NASHPA COMPRESSION FACILITY PROJECT

Tender Enquiry No.: PROC/FC/CB/PROJ/NASHPA-3268/2018

PRE-BID CLARIFICATION # 18

One of the bidder has asked following queries, OGDCL/ENAR responses are as follows:

CLIENT: **OIL&GAS DEVELOPMENT COMPANY LTD.**
OGDCL HOUSE TOWER-B, FIRST FLOOR, PHASE, BLUE AREA, JINNAH AVENUE ISLAMABAD PAKISTAN
FAX: +92 051 2822053, PHONE: +92 051 2808869

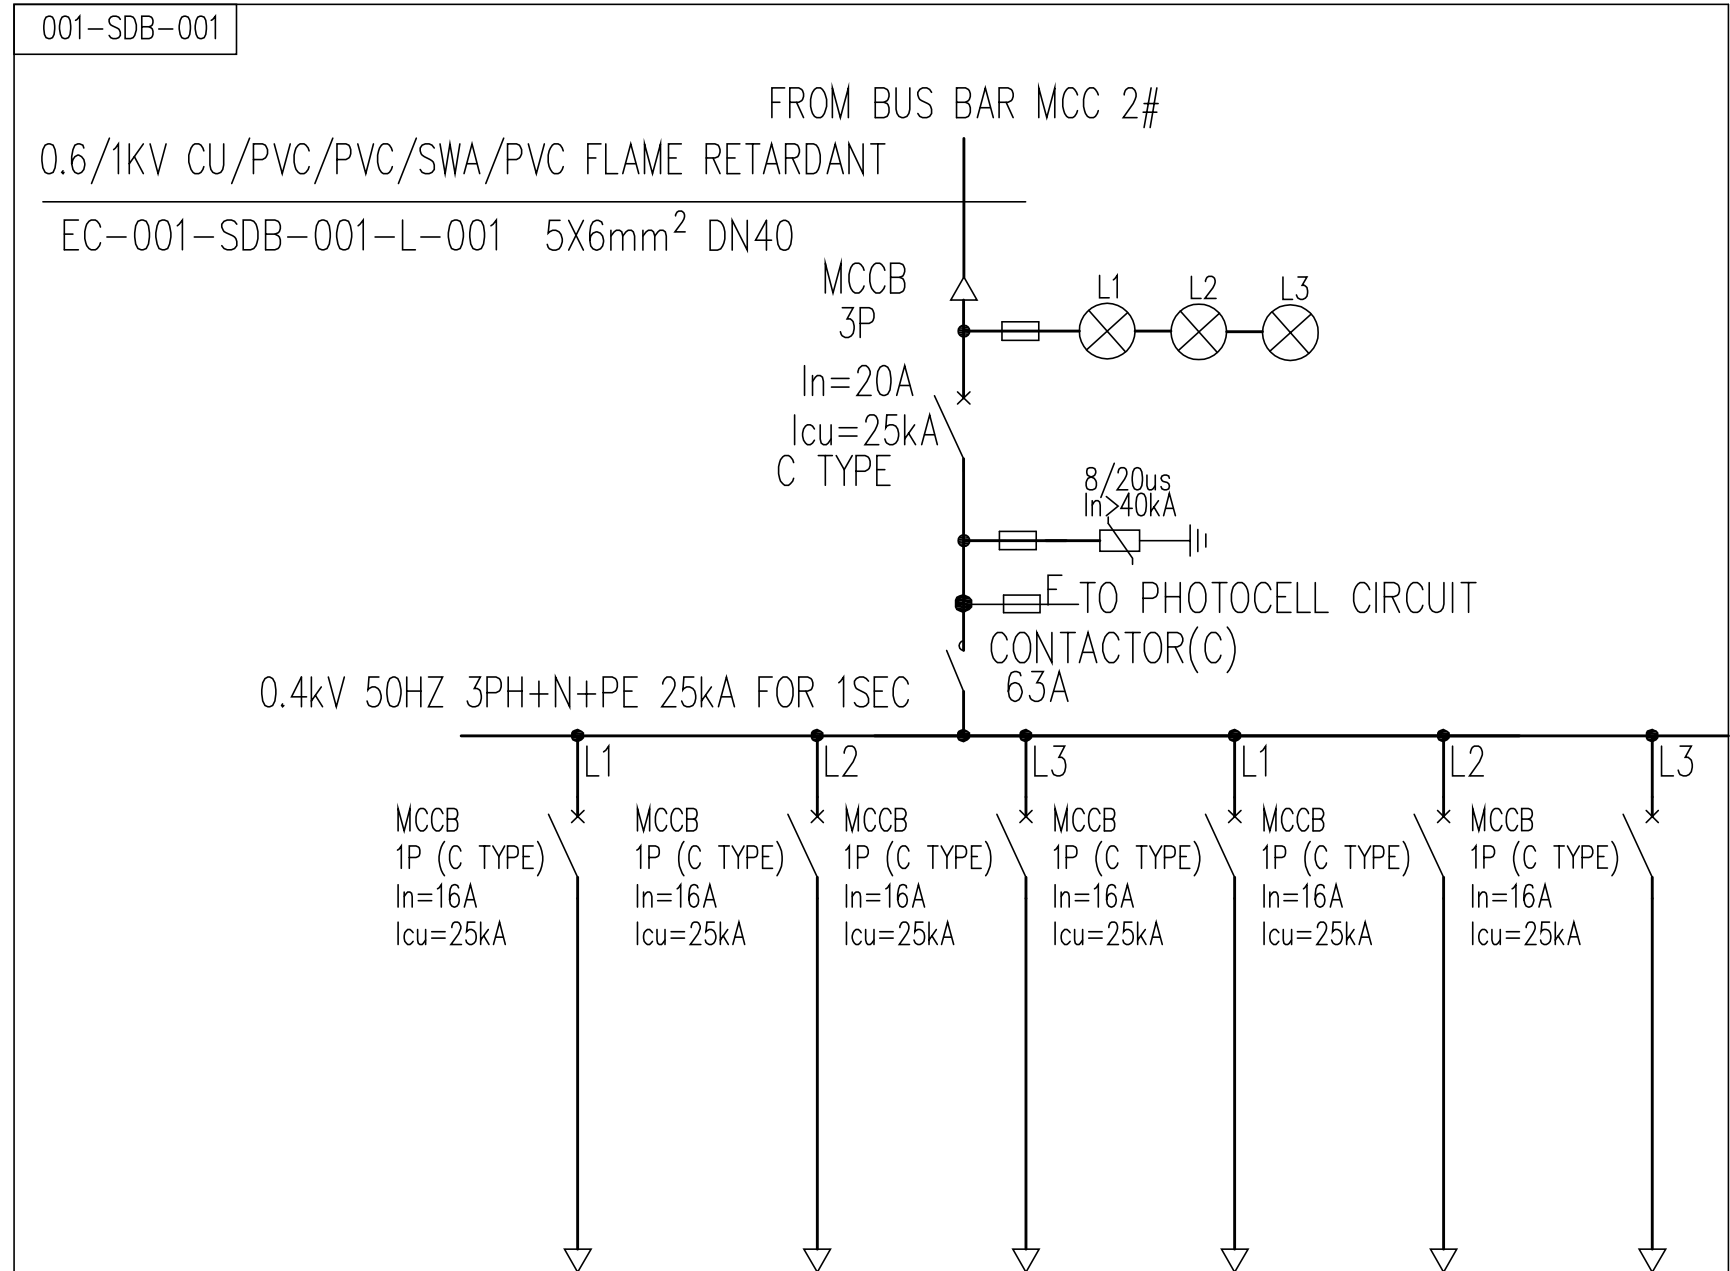
21	<p>Section 4.8 (e) of Scope of Work Page 28 of 106</p> <p>Welding Industrial sockets: 'Client to provide the Power Layout of the existing plant in which the welding industrial socket outlets are shown. This is required for suitable placement of new outlets. Client is also requested to confirm the requirement of Maximum radius that need to be covered by one welding socket. we understand that this radius should be 60m max. Client is also requested to provide the Single Line drawing of Distribution board which is feeding the power to the existing welding sockets</p>	<p>EPC Contractor to finalize the location of industrial sockets during the detailed engineering and cable routing layout for general area will be updated accordingly. The outlets shall be located such that the maximum length of lead required to reach any outlet is not more than 30 meters (in case of utility socket if required) and 50 metres (in case of welding socket).</p> <p>Power supply shall be feed from MCC#2, refer attached drawings.</p>

DRAWING TITLE: LIGHTING LAYOUT FOR INSTRUMENT & UTILITY AIR SYSTEM

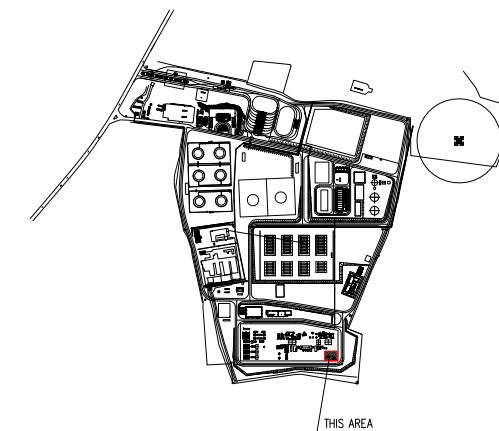
19	<p>Section 4.5.2 of Scope of Work Page 27 of 106</p> <p>'Lighting: Client to confirm that existing lighting circuit nearby the new compressors and Instrument Air Pkg area would be adequate enough to be extended. Lighting for the new scope will be provided from the existing circuits. Client is also requested to provide the existing Lighting Panel Circuit board schedules or SLDs of Lighting DBs to analyse their adequacy. Existing Lighting Layouts are also required from the client.</p>	<p>New lighting distribution boards (normal & emergency) will be considered for area/skid lighting and shall be feed from existing switchgear/MCC.</p> <p>Lighting layout for new FEED gas compressor area shall be developed by EPC Contractor during detail engineering. Refer attached drawings.</p>
20	<p>Section 4.5.2.3 of Scope of Work Page 27 of 106</p> <p>Client to confirm whether Emergency lighting fixtures (15-20%), fitted with 1 hour Battery Pack can be powered up from Normal MCC or it should be supplied from the Emergency MCC.</p>	<p>Emergency lighting shall form a minimum of 15-20% of the total number of luminaries to be installed based on lighting study report. Whereas, these emergency lighting luminaries shall also include the essential luminaries mainly positioned to illuminate escape routes and emergency exits, and shall be fitted with a battery pack that shall provide 1 hour of power.</p> <p>Emergency lighting shall be powered up from Emergency MCC.</p>
